ENGINEERING CHANGE NOTICE NO.

05110

DWG NO. 647.7700

DWG TITLE: STRUT ASSY

PARTS LIST	
APICAL INDUSTRIES	
2608 TEMPLE HEIGHTS DR.	
OCEANSIDE, CA. 92056-3512 (760)724-5300	
STRUT ASSY	
REV. 8	647.7700
SCALE NONE	SHEET 1 OF 2

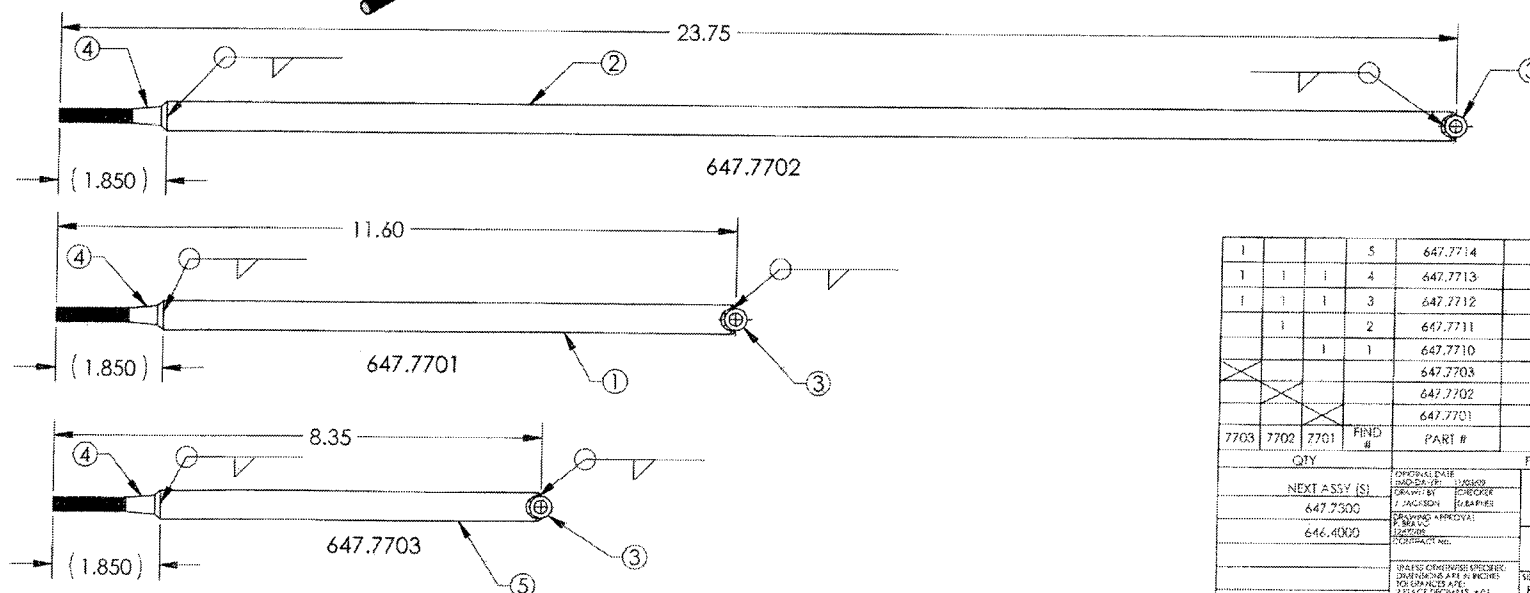
REASON: REVISED FINISH CALLOUT AS PER ECR 15-209

SHEET 1, NOTES IS:

- 1 MATERIAL: 4130 STEEL PER AMS-T-6736, .50" OD, .083" WALL THK.
- 2 MATERIAL: 4130 STEEL PER AMS-T-6736, .375" OD, .075" WALL THK.
- 3 MATERIAL: 4130 STEEL PER AMS-T-6736, .324" OD.
- 4 FINISH: PRIME IAW MIL-P-2337J TYPE I CLASS N; 1-2 MIL MAX
5. DEBURR AND BREAK ALL SHARP EDGES
6. IDENTIFY IAW MPP-120.
- 7 WELD IAW MIL-STD-2219. TIG WELD WITH FILLER ROD
- 8 FINISH: CAD PLATE IAW QQ-P-416F CLASS I TYPE II
- 9 MASK THREAD PRIOR TO FINISH

1. MATERIAL: 4130 STEEL PER AMS-T-6736, .50" OD, .083" WALL THK.
2. MATERIAL: 4130 STEEL PER AMS-T-6736, .375" OD, .075" WALL THK.
3. MATERIAL: 4130 STEEL PER AMS-T-6736, .324" OD.
4. FINISH: PRIME IAW MIL-P-2337J TYPE I CLASS N; 1-2 MIL MAX
5. DEBURR AND BREAK ALL SHARP EDGES
6. IDENTIFY IAW MPP-120.
7. WELD IAW MIL-STD-2219, TIG WELD WITH FILLER ROD
8. FINISH: CAD PLATE IAW MIL-C-5541 CLASS 1A
9. MASK THREAD PRIOR TO FINISH
